Type Test Report

Impact sound insulation box Egcosono SP

T 22/006/351 | 18.05.2022

TYPE TEST REPORT
No. T 22/006/351

name: Egcosono SP	
scale: 1 : 4	unit: mm
drawn: BW	date: 25.03.2022
MAX FRANK BUILDING COMMON GROUND

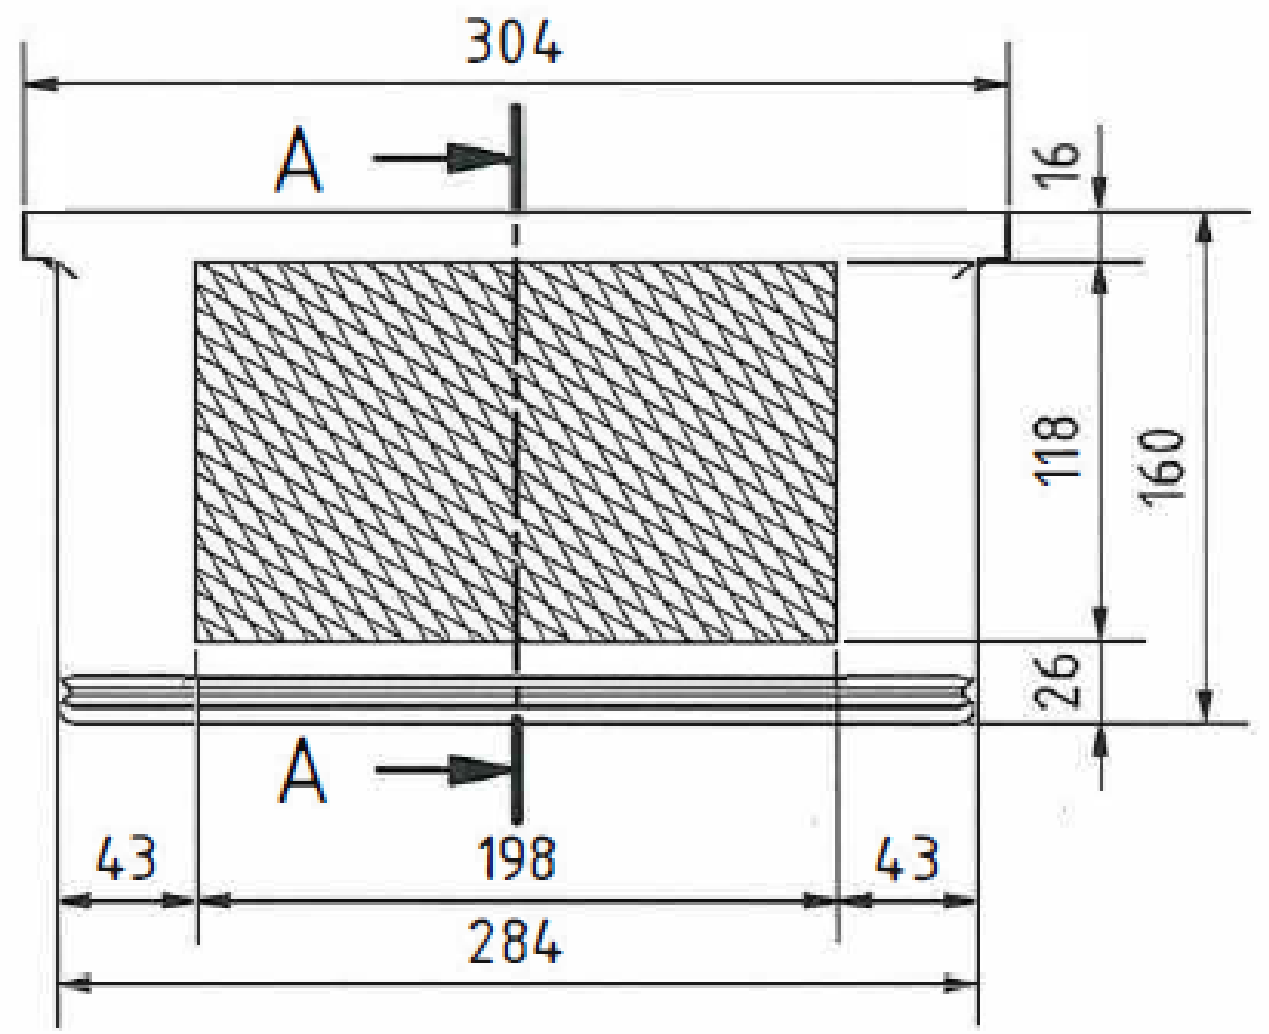
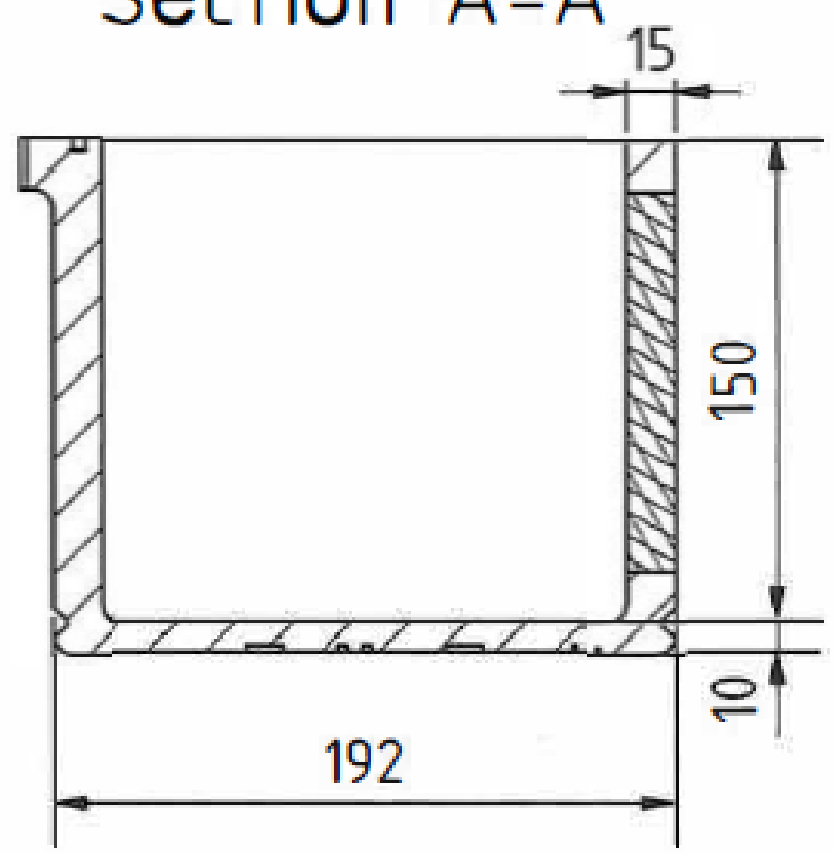
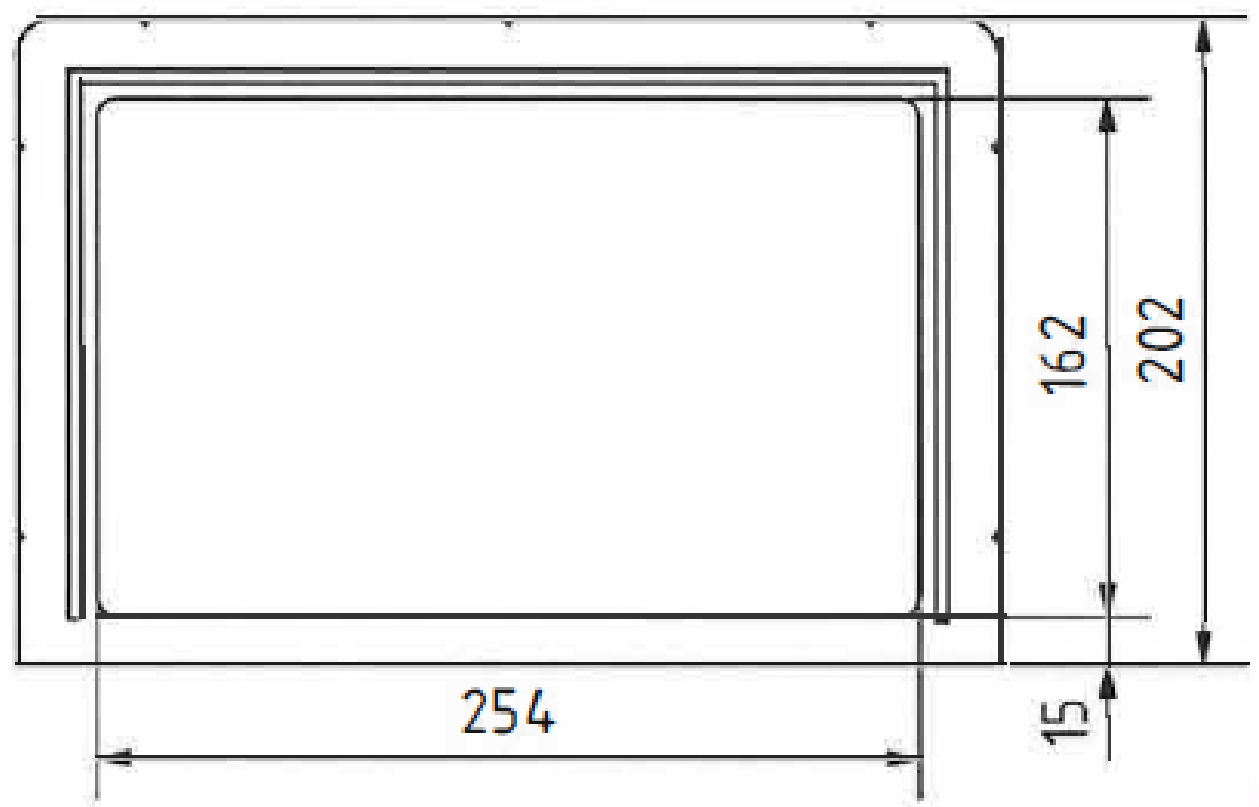
Durch Vergleichsrechnung geprüft

name: Egcosono SPV	
scale: 1 : 4	unit: mm
drawn: BW	date: 25.03.2022

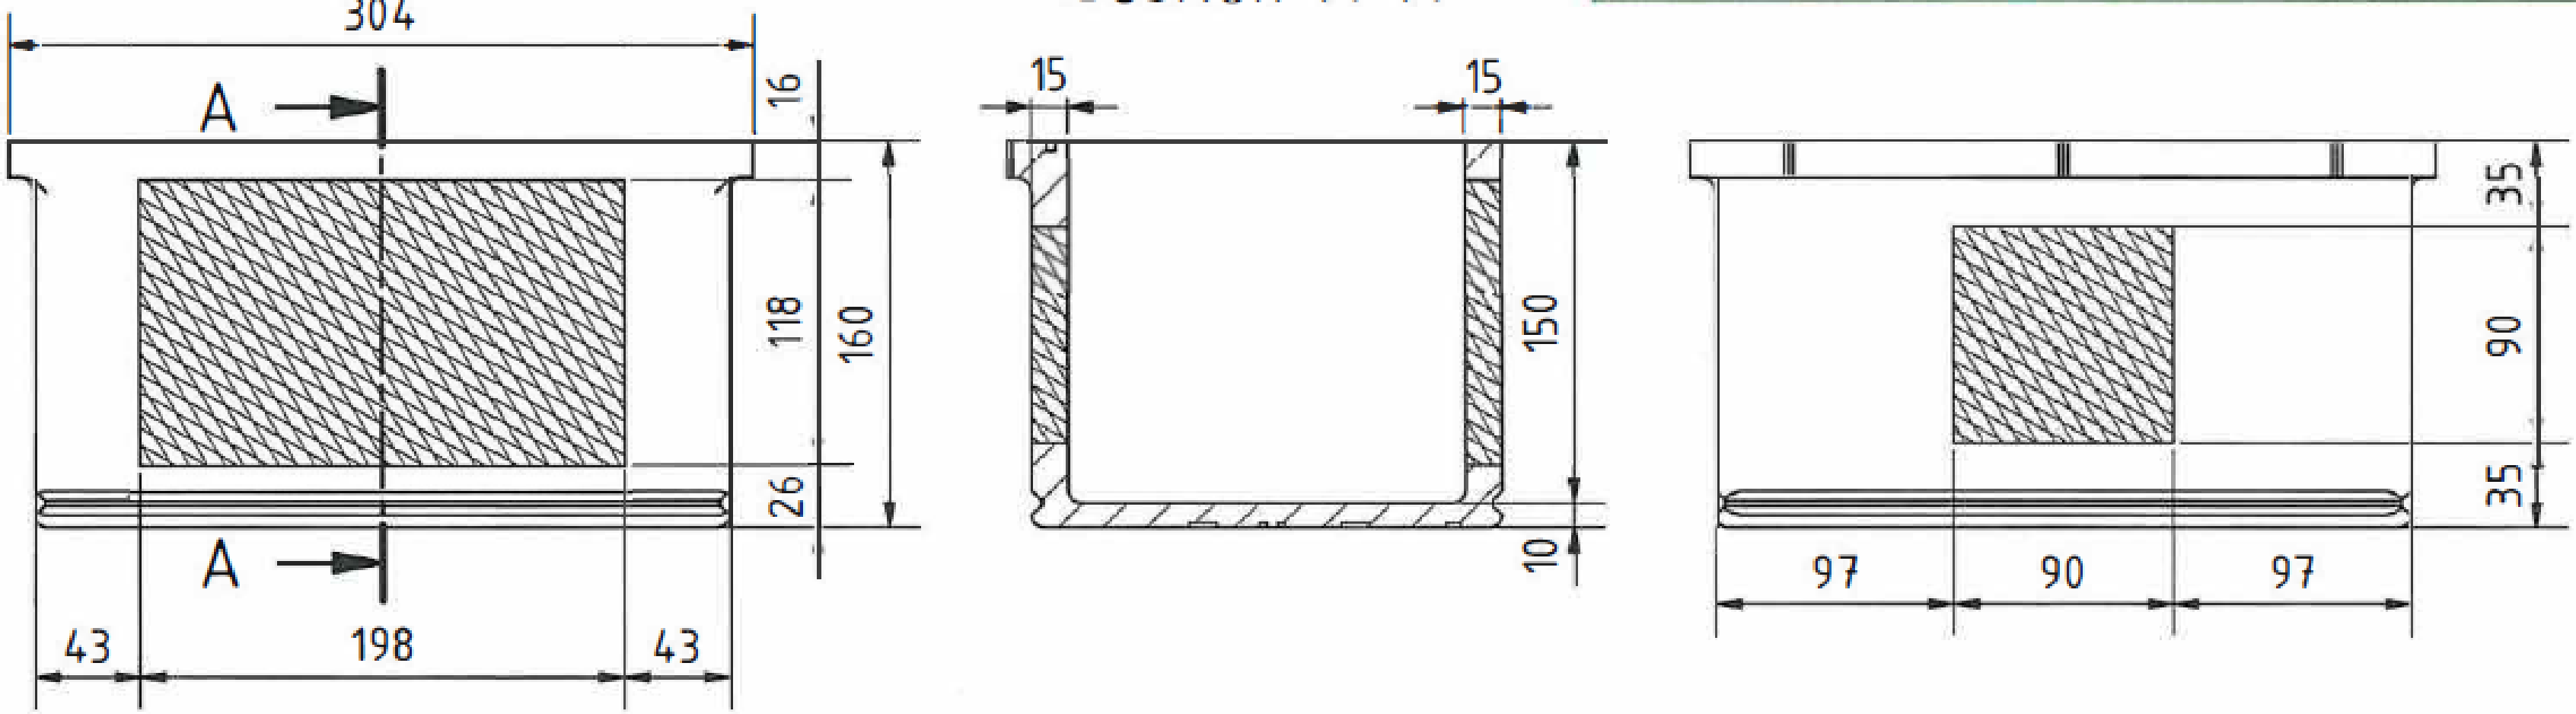
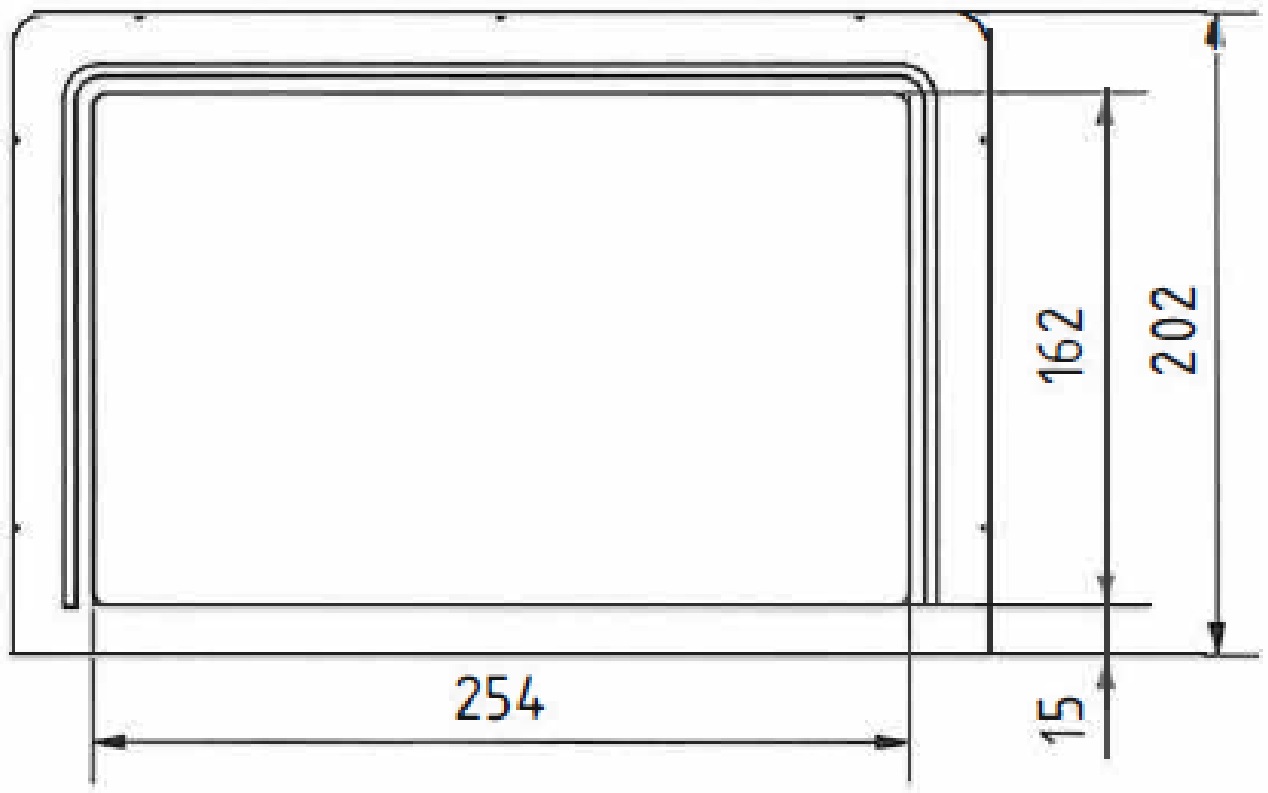
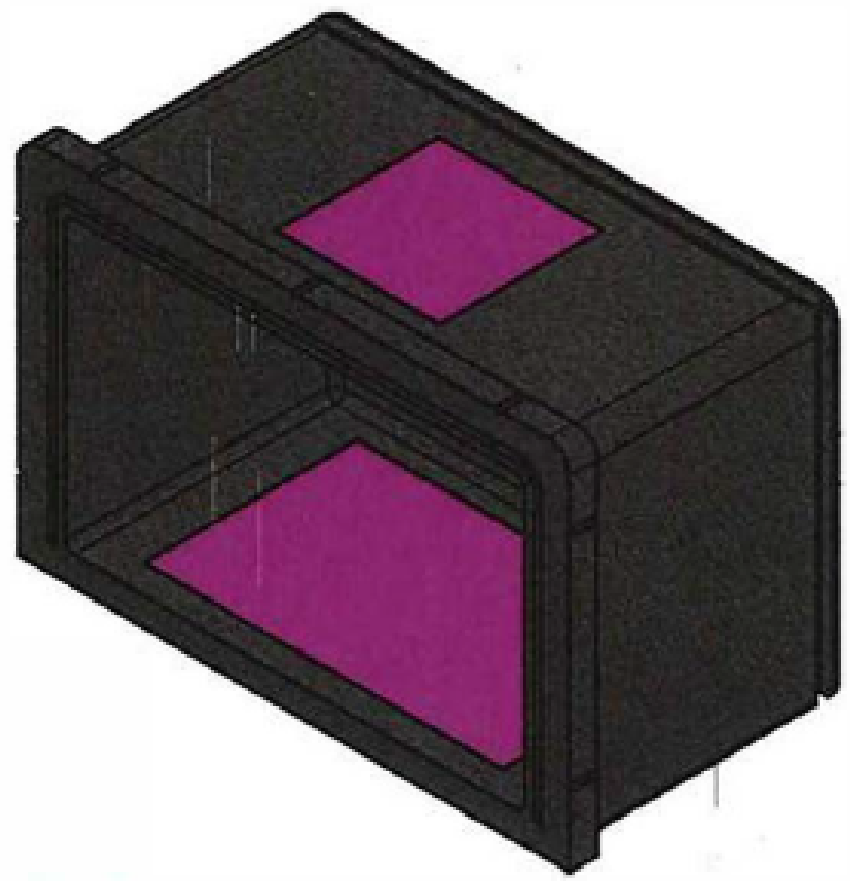
Durch Vergleichsrechnung geprüft

name: Egcosono SPH	
scale: 1 : 4	unit: mm
drawn: BW	date: 28.03.2022
MAX FRANK BUILDING COMMONGROUND

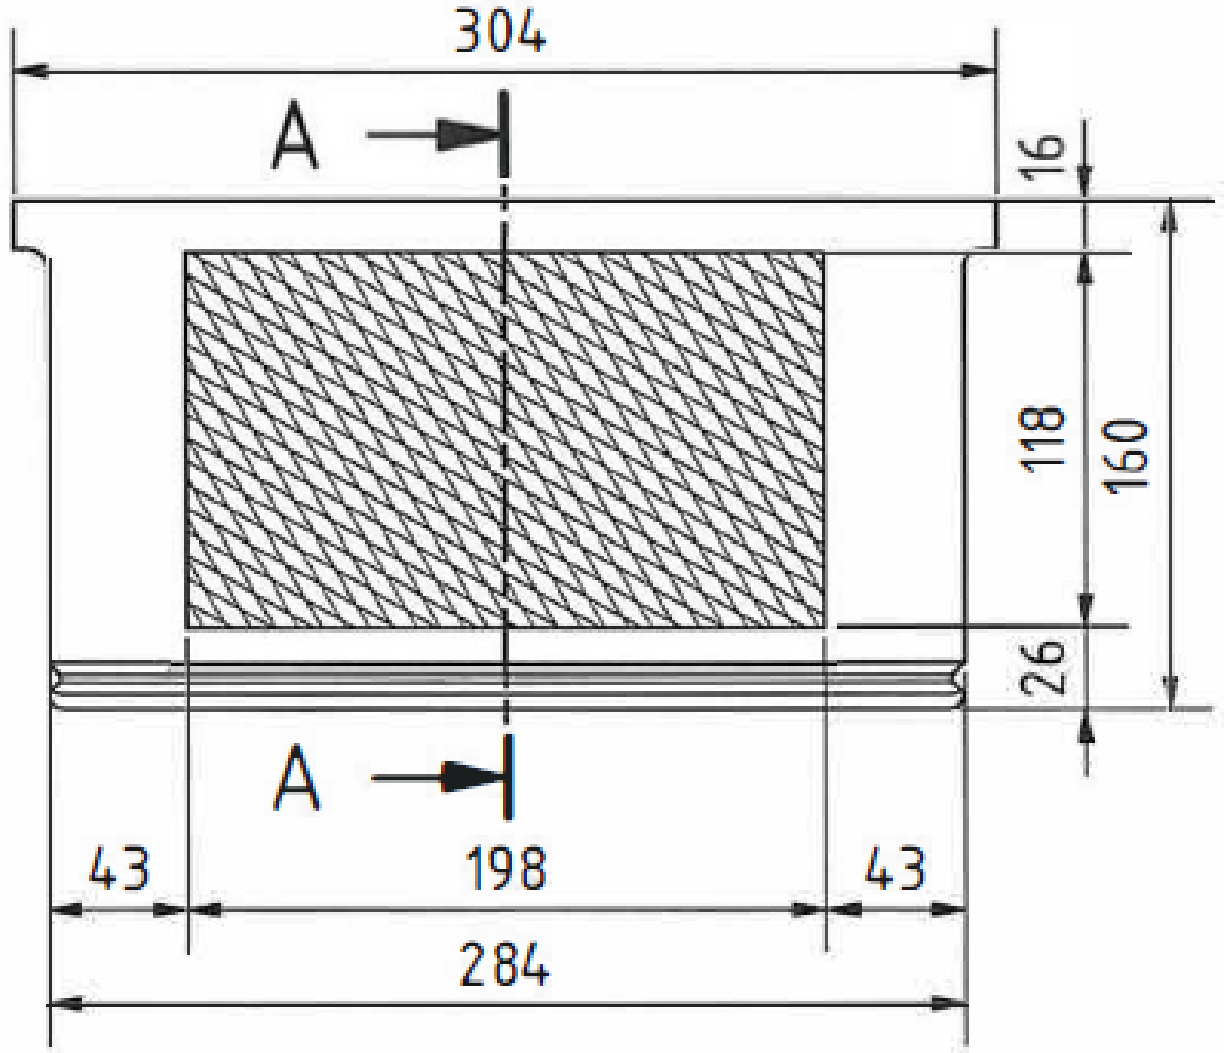
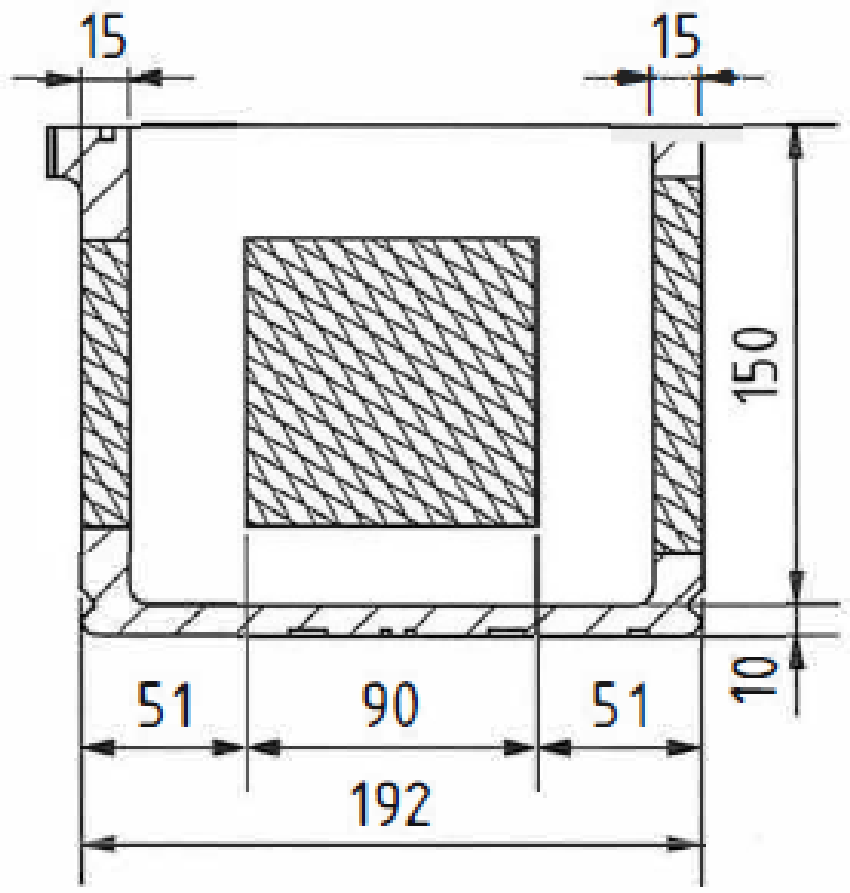
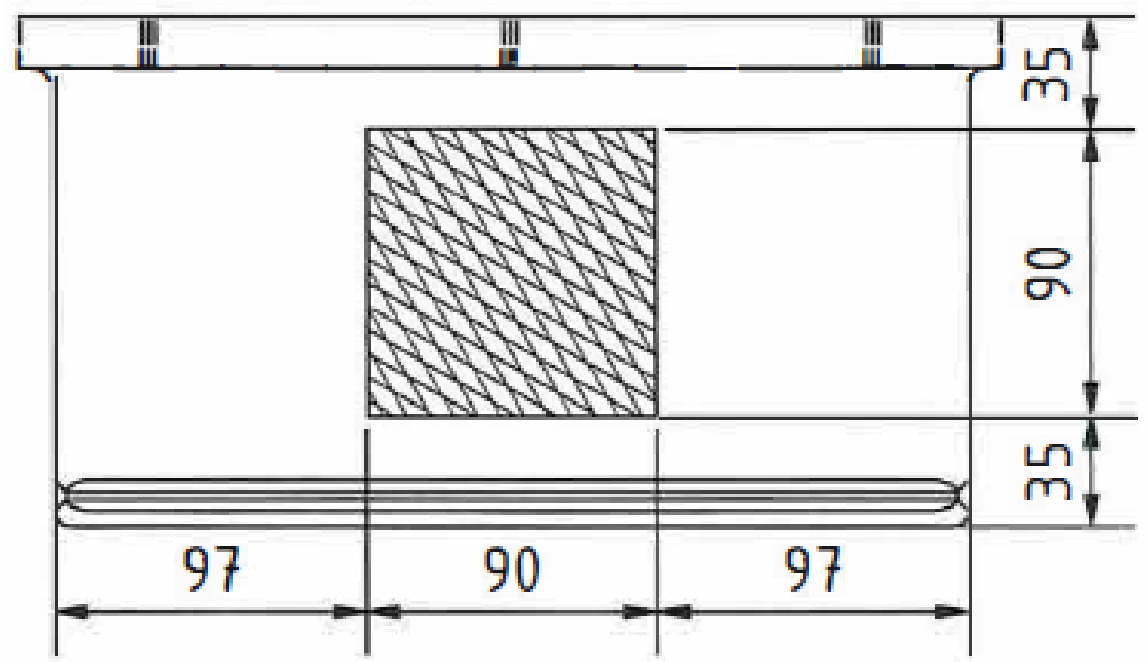
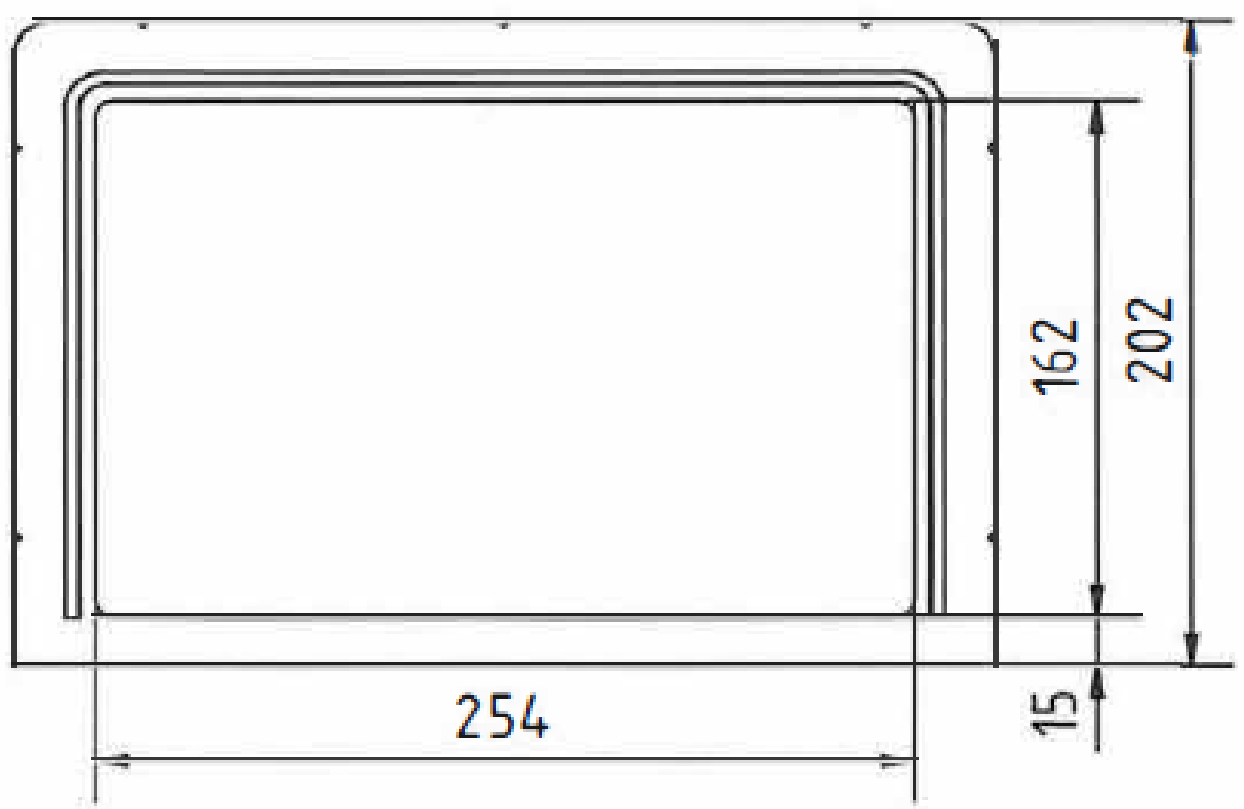
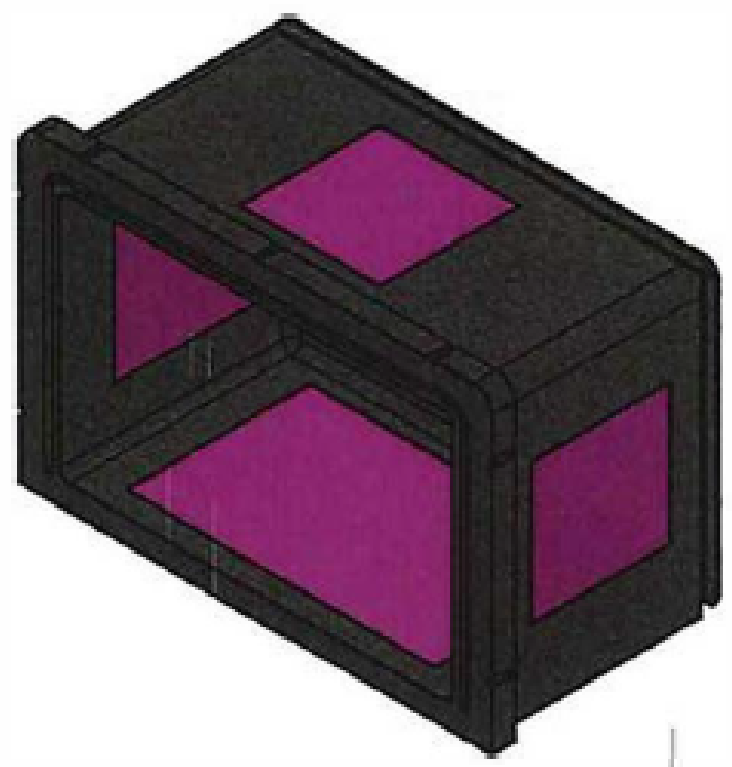
Durch Vergleichsrechnung geprüft
